Redevelopment of the Australian Technology Park
Supplementary Design Report for State Significant Development Application
Lots 8, 9 and 12 at the ATP, Eveleigh

fjmt + sissons
May 2016 – Rev DA4

Project Name		Australian Technology Park	
Project Code		MVATP	
Document Name		SSDA Supplementary Design Report	
Document ID		-	
Revision	Date	Comment	Approved
DA0	18.04.16	DRAFT	SM
DA1	21.04.16	DRAFT	SM
DA2	27.04.16	FINAL DRAFT	SM
DA3	30.04.16	FOR SUBMISSION	SM
DA4	18.05.16	FOR SUBMISSION	SM
SHADOW DIAGRAMS AND LG, MEZZANINE			
PLANS UPDATED

Height envelope overlay: view from south
Original SSDA submission overlaid with permissible height envelope

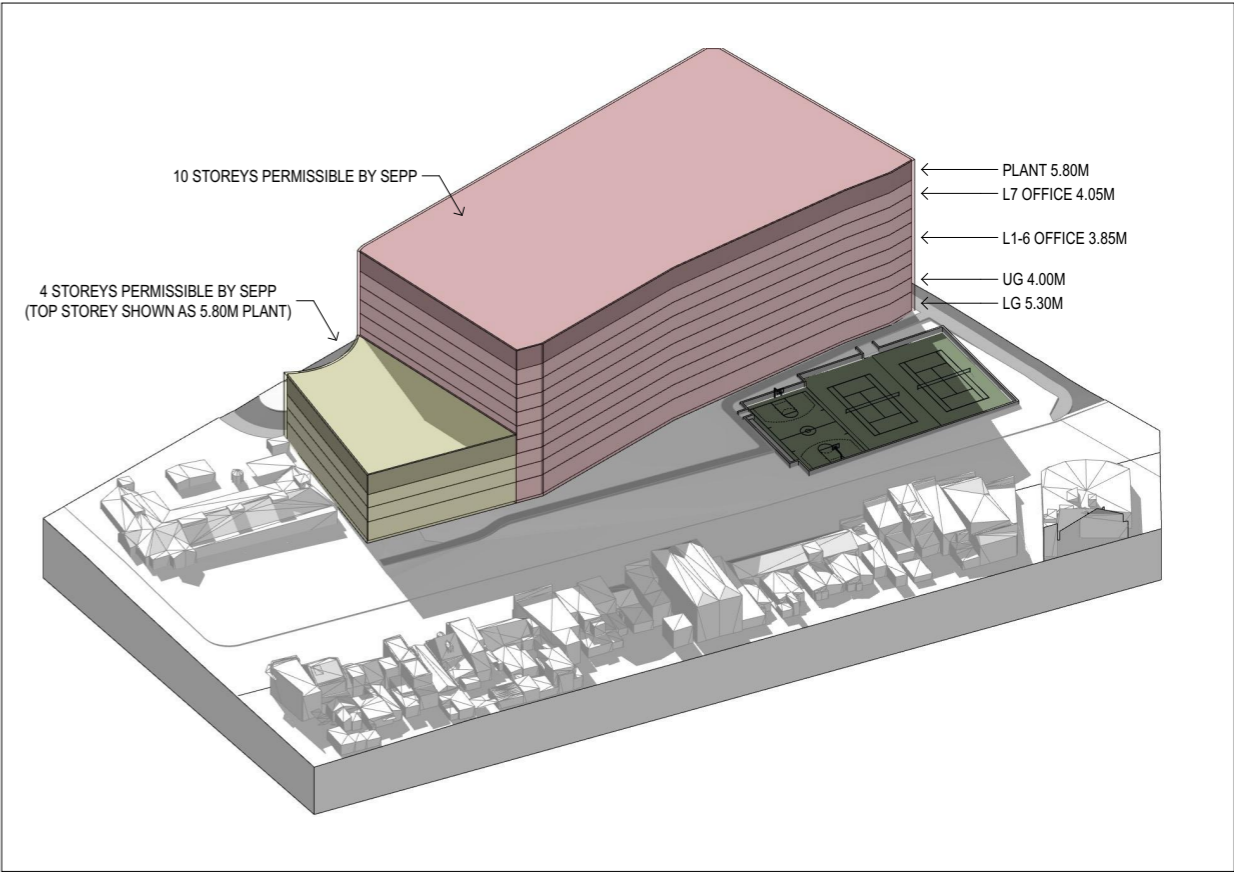
<p>Key Issue 1 GFA and building height exceedances</p>
<p>Further justification should be provided to support the variations to the gross floor area (GFA) and height controls in State Environmental Planning Policy (Major Development) 2005 (MD SEPP) and the distribution of GFA across the site. In particular, a detailed analysis of the impacts arising from the combined non-compliances are required, including:</p> <ul style="list-style-type: none">— a comparative analysis of the development as proposed and one that complies with the building height and GFA controls in 3D, plan and elevation format showing likely overshadowing impacts on neighbouring properties, particularly to the southern side of Henderson Road and the childcare centre to the west; and— a comparative visual analysis (including photomontages) as above from vantage points assessed in the Visual Impact Study.
<p>The variation (redistribution) of GFA was noted on page 12 of the SSDA Design Report. The allowable GFA is 102,450 sqm. The proposed GFA is 107,430 sqm. This represents an overall increase of 4.86%. This GFA increase and the redistribution between the sites allows for the development of 2 state of the art, technology focused commercial buildings with ground floor amenity. These buildings have been adequately sized to accommodate CBA and also to cater for the necessary amenity which ATP requires to cater for the circa 15,000 people which will use ATP everyday in the near future.</p> <p>The redistribution allows CBA's brief to be met on the ATP precinct, thus ensuring the proposals for the redevelopment of ATP were successful against considerable competition from other sites. Additionally, the reduced scale of B3 allows the community building to have a scale appropriate for its usage and reduces overshadowing to the Vice Chancellors Oval.</p> <p>The extent and height of the B1 plantrooms have been reduced relative to the original SSDA submission. Through redesign 330sqm of roof top plant has been removed from the roof of B1. Through relocation of taller elements of plant to other areas the plant associated with the south west core has been reduced in height from 5.8m to 4.0m.</p> <p>The overshadowing and visual impacts of this modified SSDA proposal have been tested against the overshadowing and visual impacts of a GFA and height compliant scheme for B1. Additionally, a solar access study has been undertaken to examine the hours of direct sunlight achieved on the Henderson Road residences at mid winter. This study is included in the following pages of this report and demonstrates that the impact of the modified proposal are no greater than those of a GFA and height compliant scheme.</p> <p>The play space for the adjacent childcare centre is to the north of the existing centre. The mid winter shadow impact is less to the childcare with the modified proposed scheme as compared to the notional height SEPP envelope as illustrated to the right, and no greater than those of a GFA and height compliant scheme</p> <p>Photomontage visual impact studies have been undertaken and are included in the following pages of this report. These illustrate that the visual impact of the modified SSDA proposal is similar, and no greater overall than that of a GFA and height compliant scheme.</p>

Diagram showing build up of permissible height envelope as used for comparison purposes in original SSDA submission.

Note: Floor to floor heights are based on actual levels of proposed scheme. Typical commercial floors are represented at 3.85m floor to floor which is a common for the building typology.
